**IN THE MATTER OF THE
REQUEST FOR FINAL PLAT
CONSISTING OF 57 BUILDING
LOTS AND 10 COMMON LOTS ON
17.64 ACRES OF LAND IN THE R-8
ZONING DISTRICT FOR
WINDROW SUBDIVISION NO. 1.**

CASE NO. FP-2024-0004

**ORDER OF CONDITIONAL
APPROVAL OF FINAL PLAT**

HEARING DATE: 6/25/2024
TO: Mayor & City Council
FROM: Stacy Hersh, Associate Planner
208-884-5533
SUBJECT: Windrow No. 1
[FP-2024-0004](#)
LOCATION: Generally located at the NEC of S. Linder Road and W. Amity Road (Parcels #S1225347078, #S1225325700, #S1225336520, #S1225336505., in the SW 1/4 of Section 25, T.3N., R.1W.

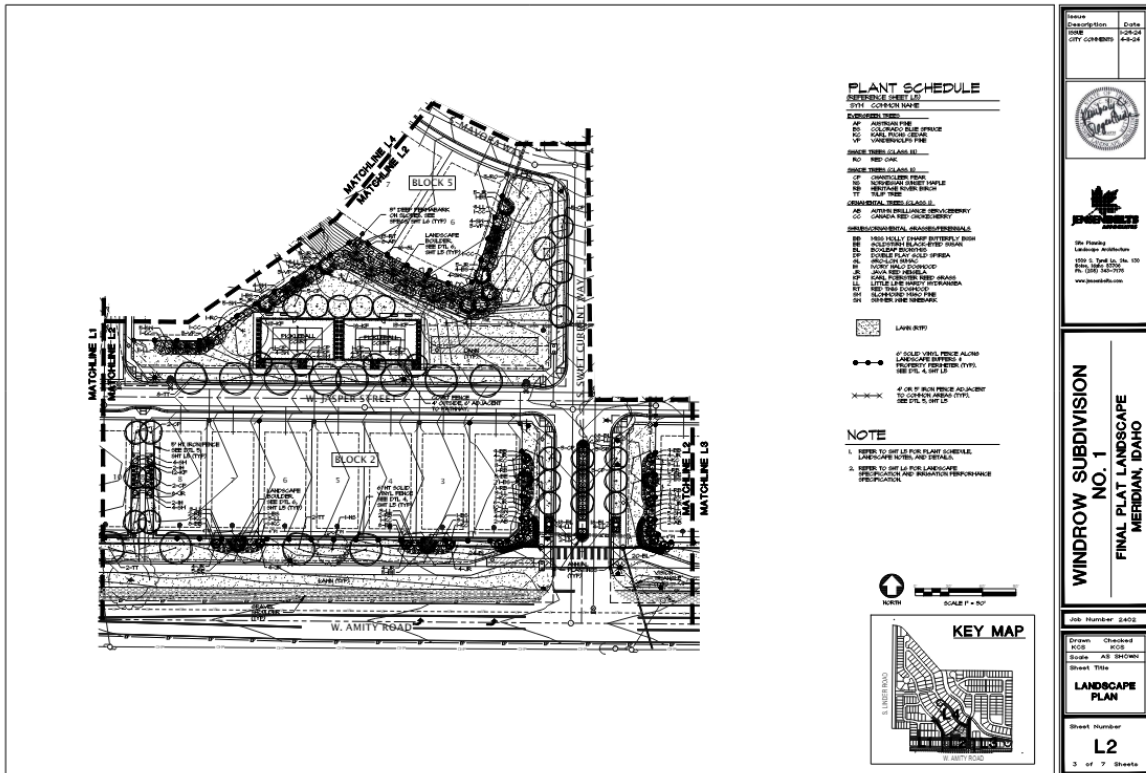
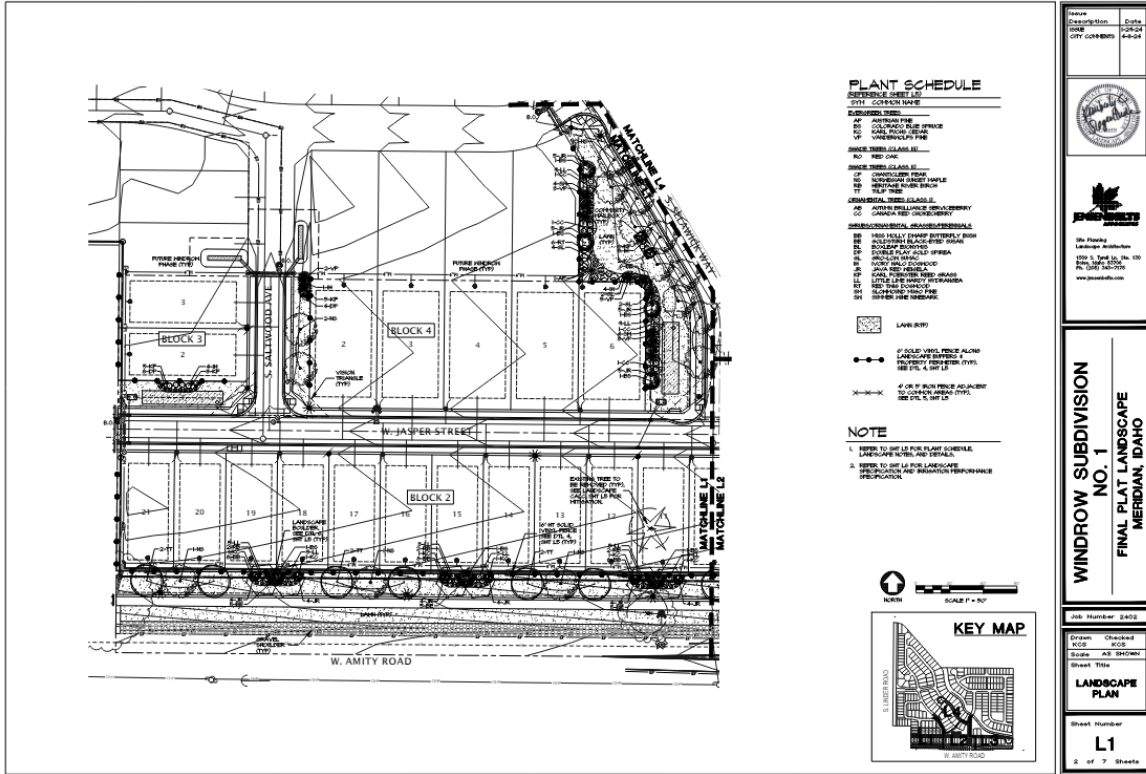
3. Prior to submittal for the City Engineer's signature, have the Certificate of Owners and the accompanying acknowledgement signed and notarized.
4. The final plat prepared by Civil Site Works, dated: 11/2/2023, included in Section V.B shall be revised as follows:

- a. Note #6: Include the recorded instrument number for the ACHD license agreement.
 - b. Note #9: Include the recorded instrument number of the Development Agreement.

- c. Note #13: Include the recorded instrument number of the ACHD sidewalk easement.
 - d. Note #14: Include the recorded instrument number of the City of Meridian Sanitary Sewer Easement.

- e. Note #15: Include the recorded instrument number of the City of Meridian Water Easement.
 - f. Add a plat note stating that direct lot access to W. Amity Road is prohibited.

- g. Replace the street name for "S. Lutana Way" with "S. Selawick Way in accordance with the Ada County Street Name Review.

A copy of the revised plat shall be submitted with the final plat for City Engineer signature.

C. Landscape Plan ((dated: 4/11/2024))

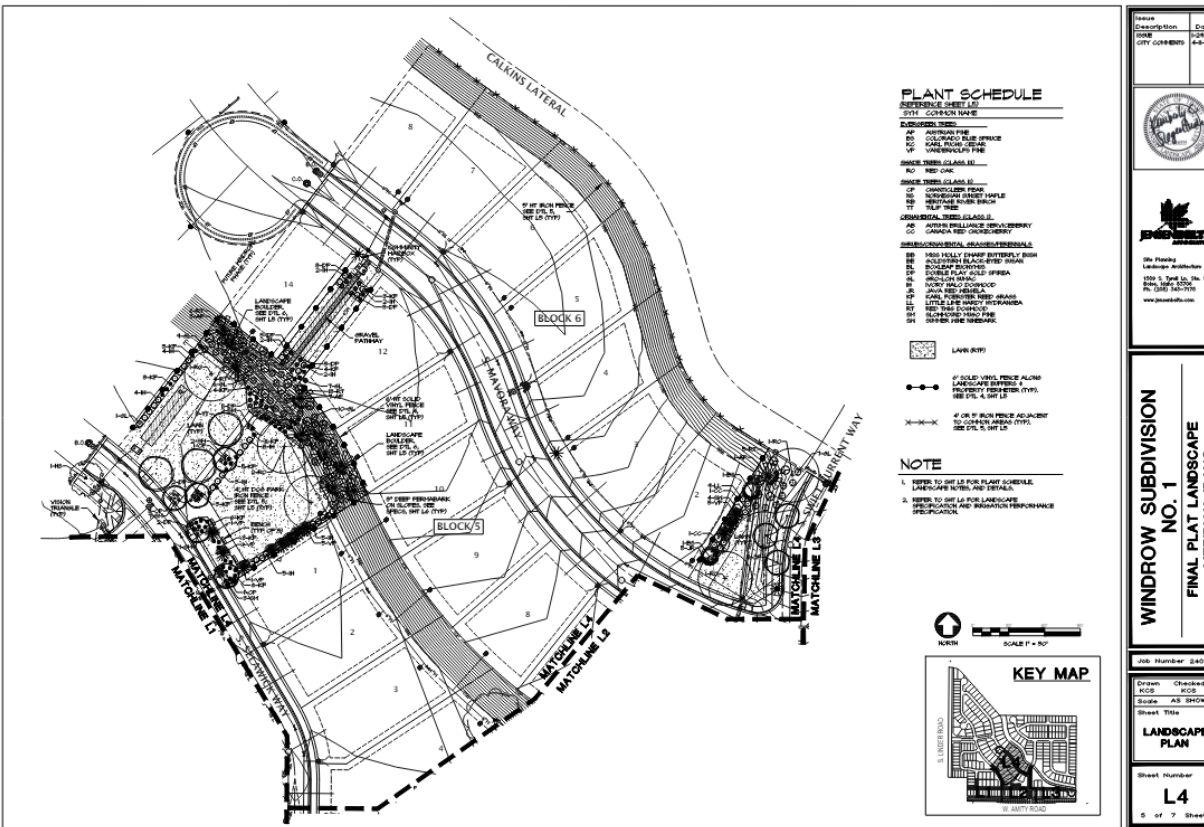
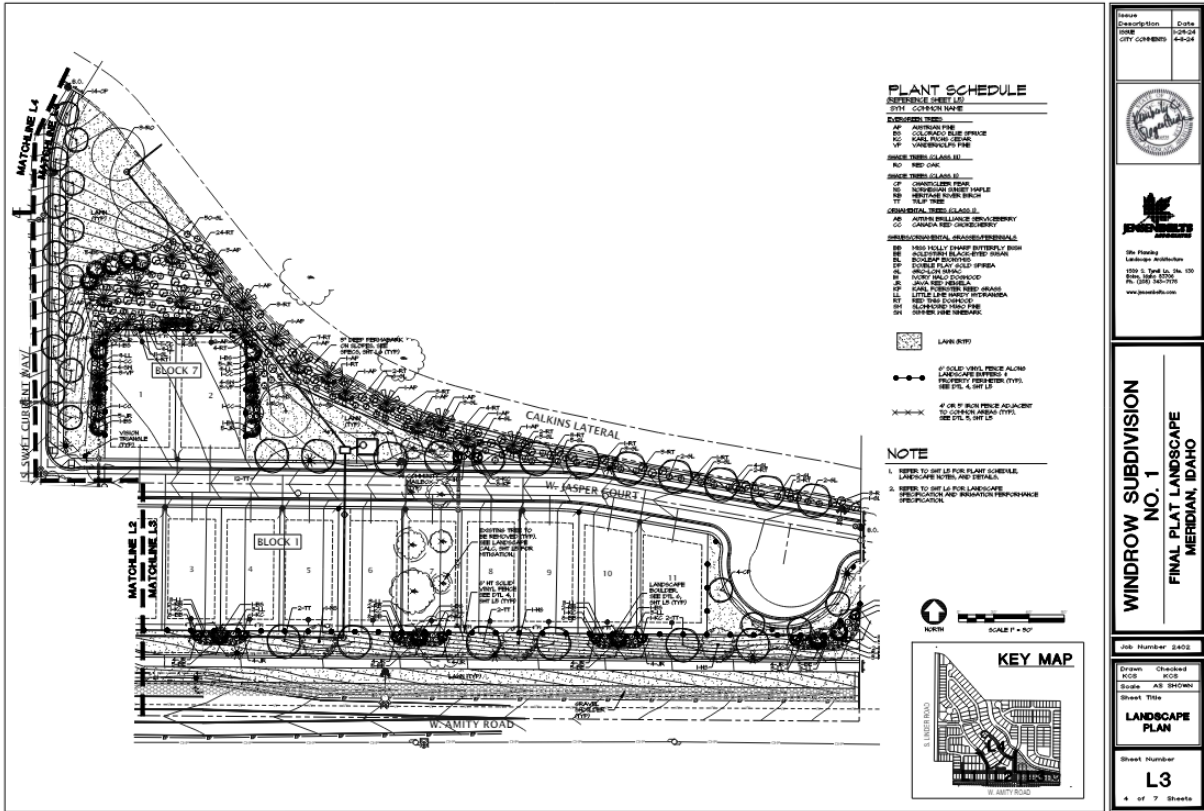
5. The landscape plan prepared by Jensen Belts, dated 4/11/2024, included in Section V.C, shall be revised as follows:
 - a. A detail for each of the amenities shall be depicted on the plan or submitted separately in compliance with the standards set forth in UDC 11-3G-4C.

- b. The micropath located on Lot 13, Block shall be paved in accordance with UDC 11-3A-5; gravel is not an approved material.
6. Off-street parking is required to be provided for all residential units in accord with the standards listed in UDC [Table 11-3C-6](#) based on the number of bedrooms per unit.
